**Re: Contract No. HY/2010/08
Central – Wan Chai Bypass – Tunnel (Slip Road 8 Section)
Additional Mitigation Plan for Slip Road 8 (Rev. 7)**

Additional Mitigation Plan for Slip Road 8 (Revision 7) under FEP-10/364/2009/B for Contract No. HY/2010/08

**Central – Wan Chai Bypass Tunnel
(Slip Road Section 8)
Contract No. HY/2010/08**

Additional Mitigation Plan for Slip Road 8 under condition 2.16 of FEP- 10/364/2009/B

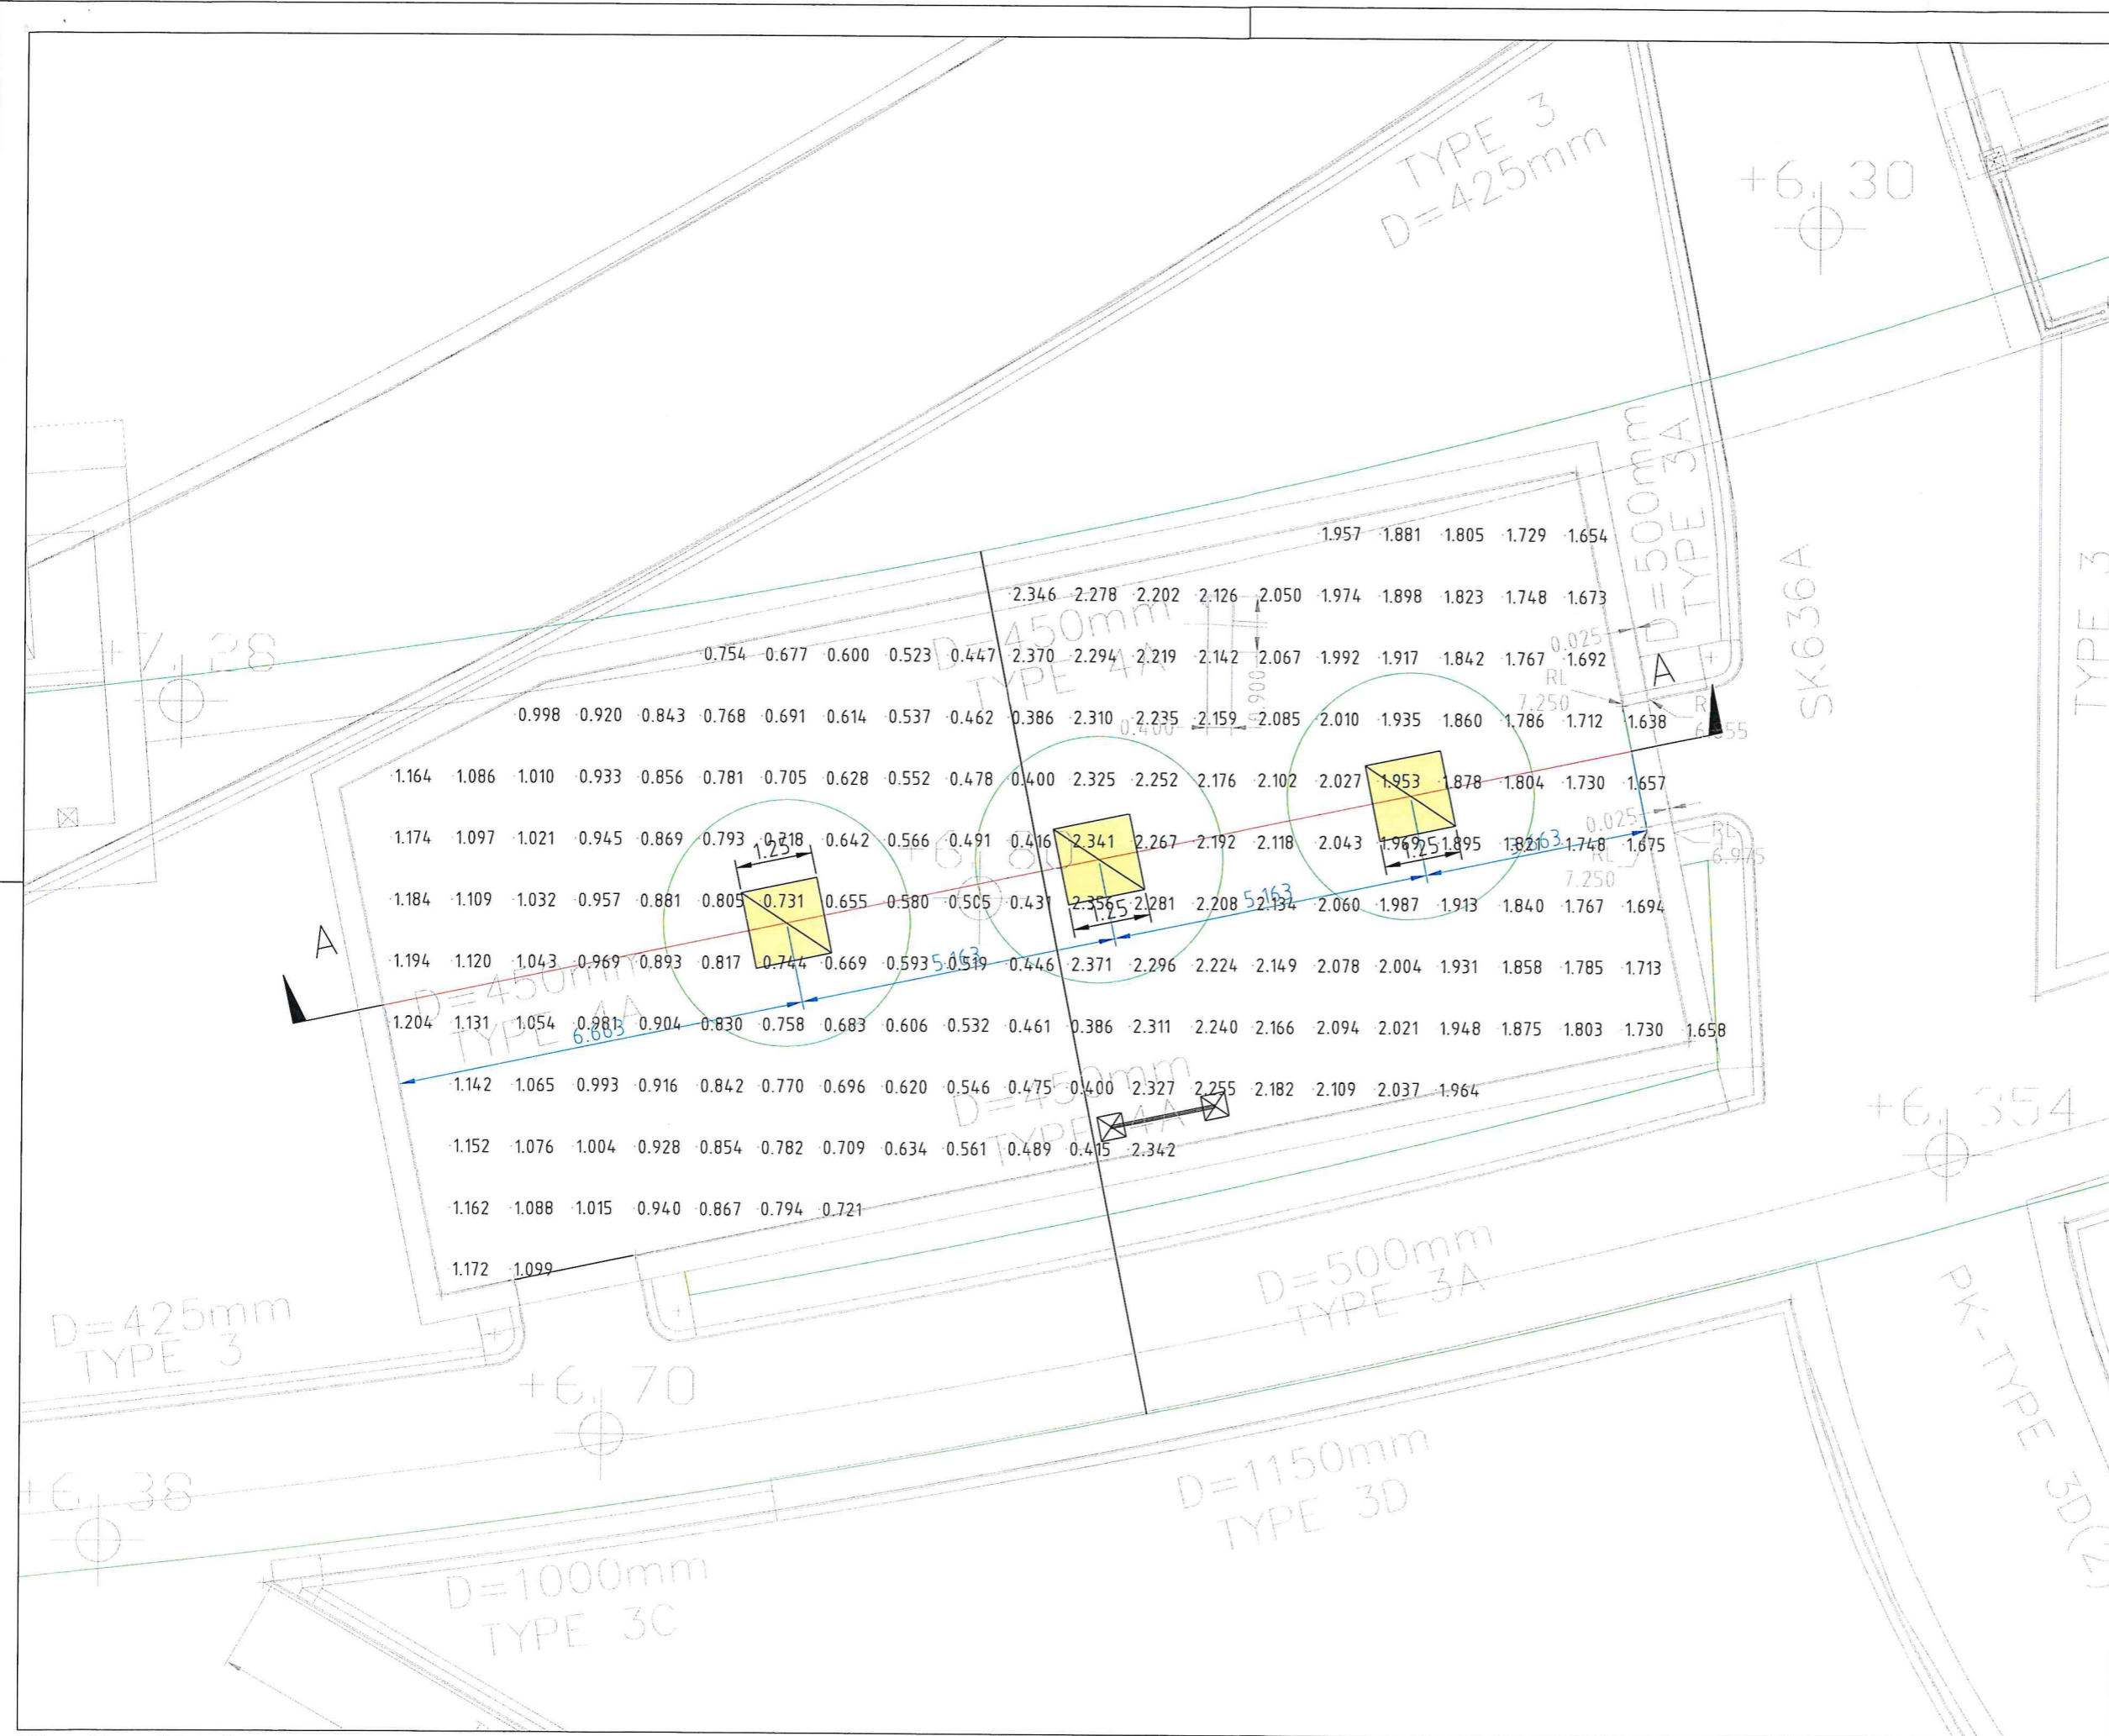
As checked and informed by the Contractor, there would be insufficient cover for installing the equipment due to structural feature below the Elderly Facilities area. We have to slightly shift the layout to suit. Please advise if you have any comment to the revised layout. Details are attached for your reference.

According to the site record, we found the design clearance of the elderly facilities at the middle area is not sufficient to install the proposed equipment. Therefore, we propose to shift the whole set of the equipment 1.5m toward east side. We also checked that the safety zone of the revised location is complied with LCSD's requirement (1830mm). Please assist us to seek for VPMO comment.

As confirmed by VPMO, we have no objection to the revised layout of elderly fitness facilities.

We have no comment for the revised location of elderly facilities.

TITLE:
 LAYOUT FOR ELDERLY FITNESS AREA
 IN VICTORIA PARK

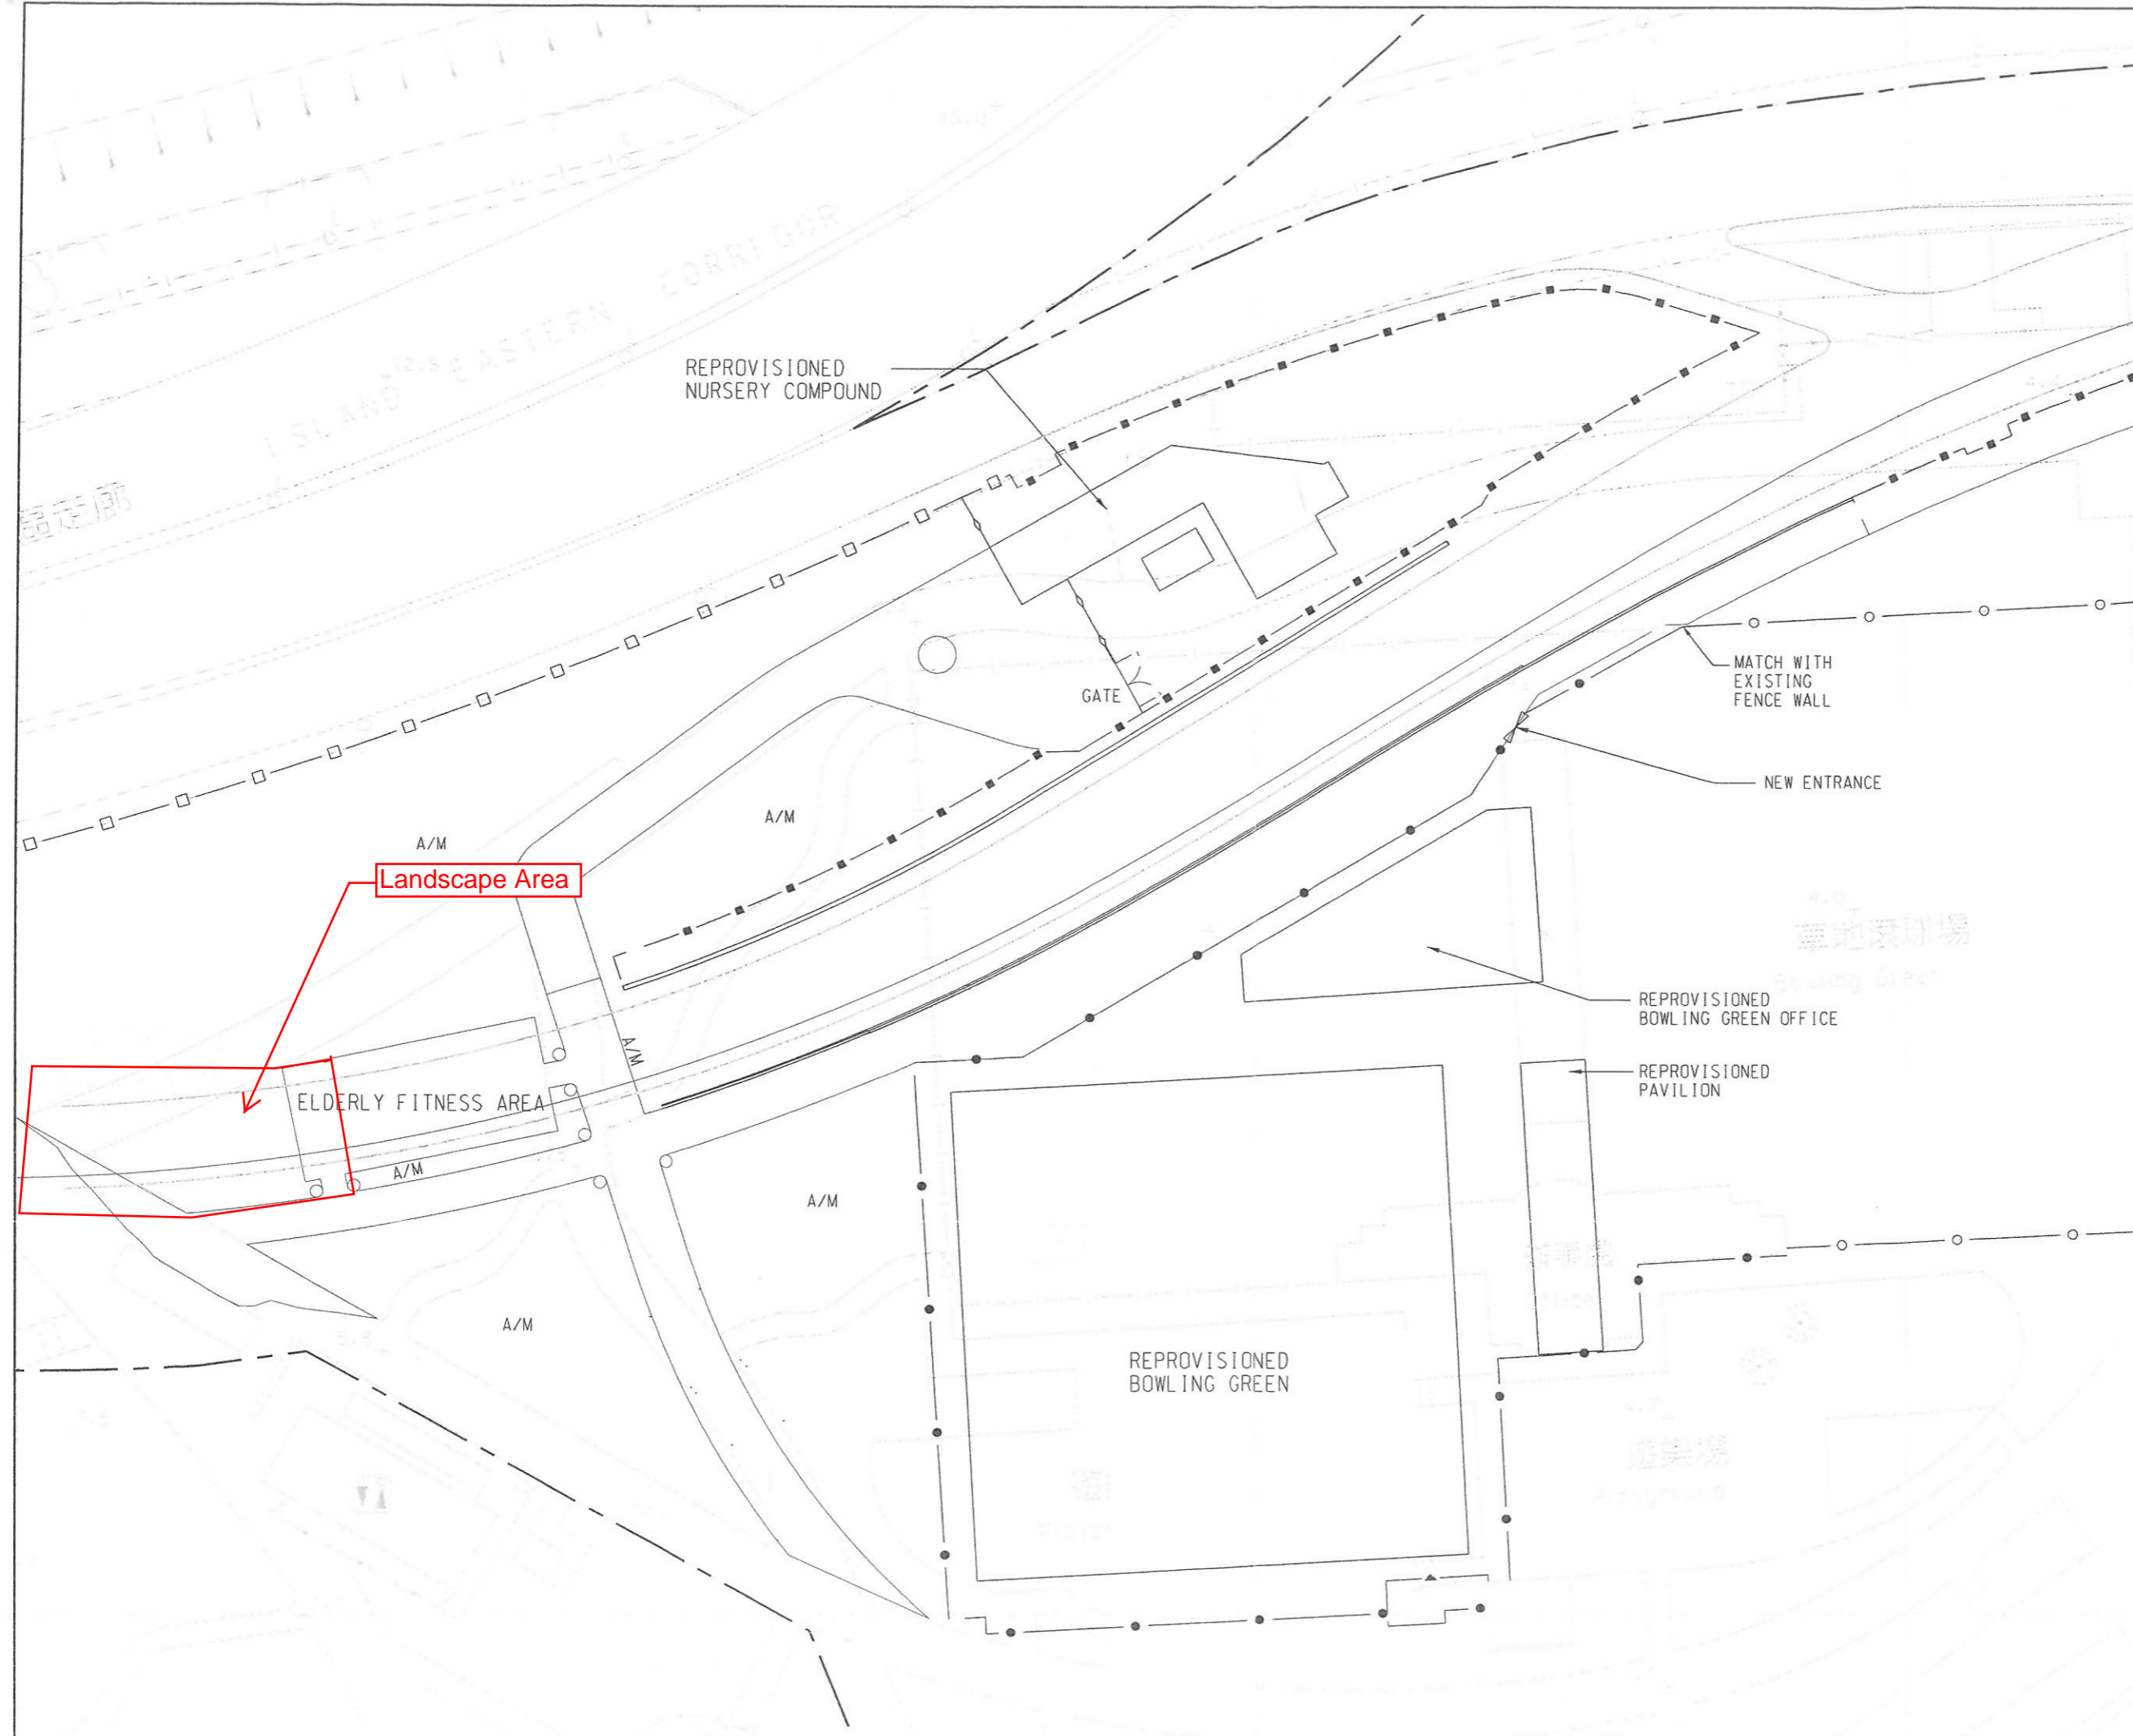
Variation Order No. V/039
Additional Elderly Fitness Facilities within Victoria Park

1. Supply similar to the attached photographs and install three sets (maximum) elderly fitness equipment as discussed and recorded in Victoria Park Working Group Meeting No. 47 in the "Elderly Fitness Area" as shown on the attached Sketch No. 60095653/T2/SK0720. The exact details and location of the elderly fitness equipment shall be confirmed and agreed on site with the ER.
